Access Compliance Report

Public Rights-of-Way

Intersection ID: N/A	Main Street: LAWYERS_RD	Cross Street: COVINGTON_COMMONS_DR	Location: NE
ADA ID: F69F44E78E51	Ramp Type: PerpDiag	Initial Pass/Fail: Fail	Overall Compliance: No
		Severity Score: 21.25

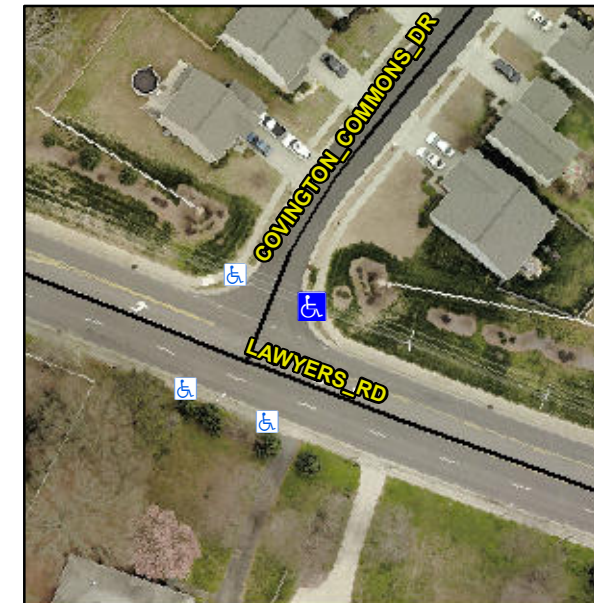
Not Found, R304.5.1, R304.2.2

Compliance	Description	Data	Compliance	Description	Data
N/A	Ramp Length (in)	49.0	No	Ramp Slope (%)	9.3
No	Ramp Width (in)	47.0	Yes	Ramp XSlope (%)	0.2
N/A	Flare Type LT	N/A	N/A	Flare Type RT	N/A
N/A	Flare Slope LT (%)	N/A	N/A	Flare Slope RT (%)	N/A
N/A	Flare Traversable LT?	N/A	N/A	Flare Traversable RT?	N/A
N/A	Landing Length (in)	N/A	N/A	DWS Provided?	N/A
N/A	Landing Width (in)	N/A	N/A	DWS Contrast?	N/A
N/A	Landing Slope (%)	N/A	N/A	DWS Length (in)	N/A
N/A	Landing X Slope (%)	N/A	N/A	DWS Full Width?	N/A
N/A	Landing Curb? (Y/N)	N/A	N/A	DWS Offset (in)	N/A
N/A	Shared Landing?	N/A			
N/A	Gutter Ponding?	N/A	N/A	Gutter Slope (%)	N/A
N/A	Gutter Lip Ht (in)	N/A	N/A	Gutter X Slope (%)	N/A
N/A	Painted X Walk1?	No	N/A	Painted X Walk2?	No
	X Walk 1 Direction	To NW		X Walk 2 Direction	To SW
N/A	X Walk 1 Width (in)	N/A	N/A	X Walk 2 Width (in)	N/A
	X Walk 1 Slope (%)	0.2		X Walk 2 Slope (%)	3.1
	X Walk 1 X Slope (%)	0.5		X Walk 2 X Slope (%)	0.2

Remove & Replace Curb Ramp With Two New Directional Ramps or Equivalent.
